# Access Compliance Report

## Public Rights-of-Way

Intersection ID: 43359	Main Street: WOODLAND COMMONS DR	Cross Street: RIDGEVIEW COMMONS DR	Location:	N
ADA ID: D27058F50C69	Ramp Type: Perp	Initial Pass/Fail: Pass	Overall Compliance: No	Severity Score: 5

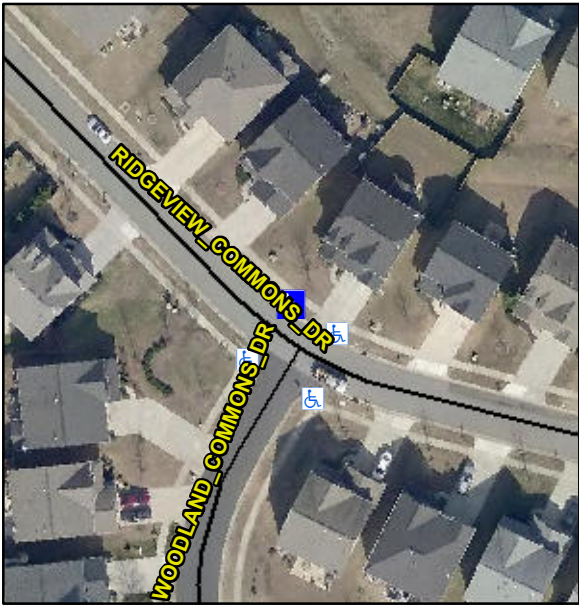
Codes/Mitigation Info/Possible Solution			Field Measurements/Component Compliance							
	Possible Solutions:		<b>Compliance</b>			<b>Description</b>			<b>Data</b>	
	<b>Remove &amp; Replace Landing.</b>		<b>N/A</b>	Ramp Length (in)	<b>72.0</b>	<b>Yes</b>	Ramp Slope (%)	<b>6.1</b>		
	<b>Remove &amp; Replace Gutter.</b>		<b>Yes</b>	Ramp Width (in)	<b>48.0</b>	<b>Yes</b>	Ramp XSlope (%)	<b>1.4</b>		
			<b>N/A</b>	Flare Type LT	<b>Sloped</b>	<b>N/A</b>	Flare Type RT	<b>N/A</b>		
			<b>N/A</b>	Flare Slope LT (%)	<b>3.6</b>	<b>N/A</b>	Flare Slope RT (%)	<b>5.9</b>		
			<b>N/A</b>	Flare Traversable LT?	<b>No</b>	<b>N/A</b>	Flare Traversable RT?	<b>No</b>		
			<b>Yes</b>	Landing Length (in)	<b>48.0</b>	<b>Yes</b>	DWS Provided?	<b>Yes</b>		
			<b>Yes</b>	Landing Width (in)	<b>48.0</b>	<b>Yes</b>	DWS Contrast?	<b>Yes</b>		
			<b>No</b>	Landing Slope (%)	<b>3.0</b>	<b>Yes</b>	DWS Length (in)	<b>24.5</b>		
			<b>Yes</b>	Landing X Slope (%)	<b>0.7</b>	<b>Yes</b>	DWS Full Width?	<b>Yes</b>

Surveyor Notes:		<b>N/A</b>			<b>N/A</b>	Landing Curb? (Y/N)	<b>No</b>	<b>Yes</b>	DWS Offset (in)	<b>0.0</b>
		<b>N/A</b>			<b>N/A</b>	Shared Landing?	<b>Yes</b>			
PROW/ADA:		<b>R304.2.2-Perp, R304.3.2-Para, R304.5.4</b>			<b>Yes</b>	Gutter Ponding?	<b>No</b>	<b>No</b>	Gutter Slope (%)	<b>5.8</b>
					<b>Yes</b>	Gutter Lip Ht (in)	<b>0.0</b>	<b>Yes</b>	Gutter X Slope (%)	<b>1.1</b>
					<b>N/A</b>	Painted X Walk1?	<b>No</b>	<b>N/A</b>	Painted X Walk2?	<b>N/A</b>
						X Walk 1 Direction	<b>To SW</b>		X Walk 2 Direction	<b>N/A</b>
					<b>N/A</b>	X Walk 1 Width (in)	<b>N/A</b>	<b>N/A</b>	X Walk 2 Width (in)	<b>N/A</b>
						X Walk 1 Slope (%)	<b>0.4</b>		X Walk 2 Slope (%)	<b>N/A</b>
						X Walk 1 X Slope (%)	<b>2.3</b>		X Walk 2 X Slope (%)	<b>N/A</b>
					<b>N/A</b>	Ramp inside XWalk1?	<b>N/A</b>	<b>N/A</b>	Ramp inside XWalk2?	<b>N/A</b>
						Road Slope (%)	<b>N/A</b>	<b>N/A</b>	Clear Space?	<b>Yes</b>
